Comparison of dimensions

K2-A2 (56C motor)

The new K2-K4-K5 variator is a restyling of type A2-A4-A8-A10-A12. All the fixing dimensions are unchanged, only few secondary measures change.

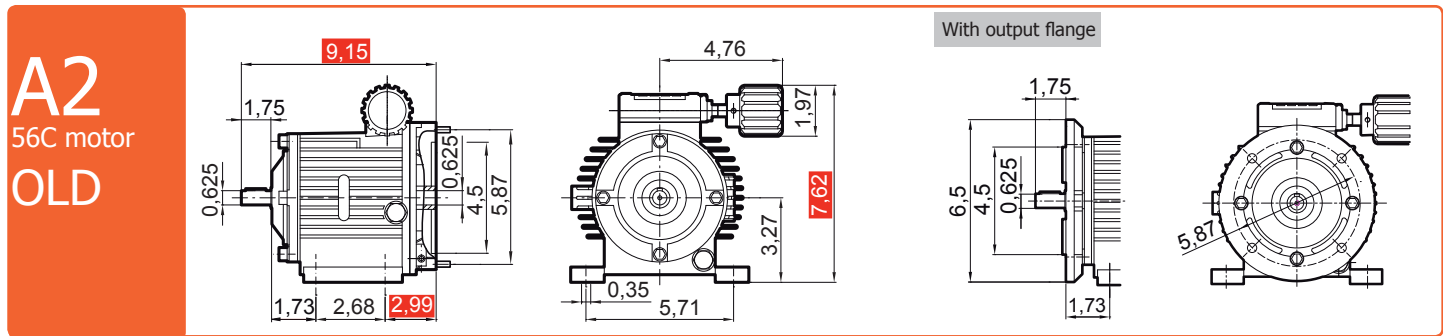
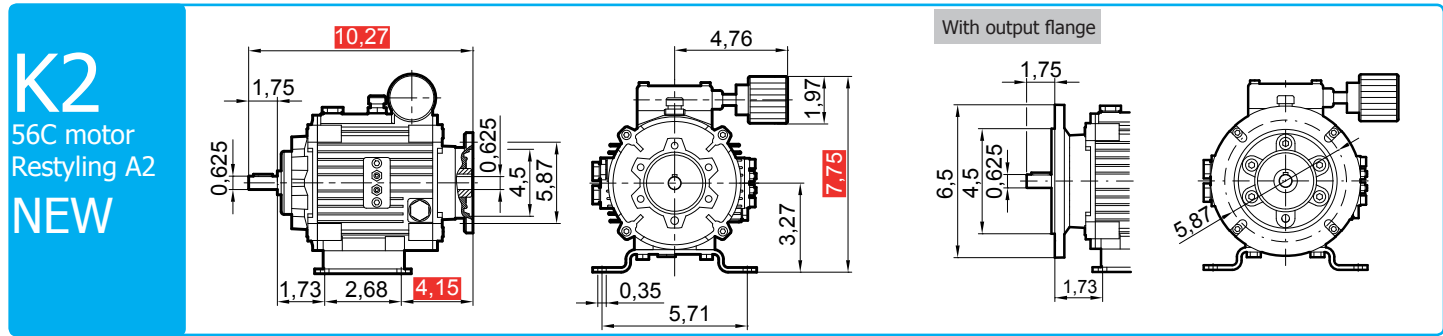
All mounting dimensions are the same, only coloured measures are different **10,27**
